STORMWATER AUDIT (STAGE 1)

JBA Project Code 2026s0294
Contract Caheranardish, Mungret LRD – Stage 1 Stormwater Audit
Client OSL Butler Consulting Engineers Ltd.
Prepared by Jack Shanahan & Aneeqe Ahmed
Subject Stormwater Audit Stage 1 Report

2 Proposed Development Caheranardish, Mungret, Co. Limerick

Figure 2 Surface Water Sub-Catchments (extract from Surface Water Report)

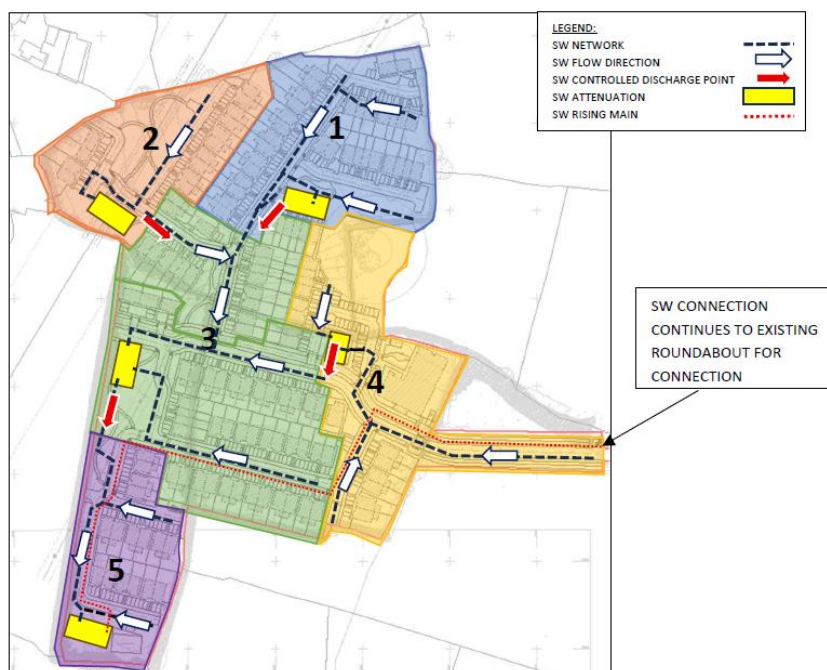
It is not clearly stated which areas drain to each detention basin, nor whether runoff entering these basins is intended to infiltrate prior to entering the downstream attenuation tanks.

OSL to confirm what areas enter each detention basin and whether it is intended for them to infiltrate into the attenuation tanks.
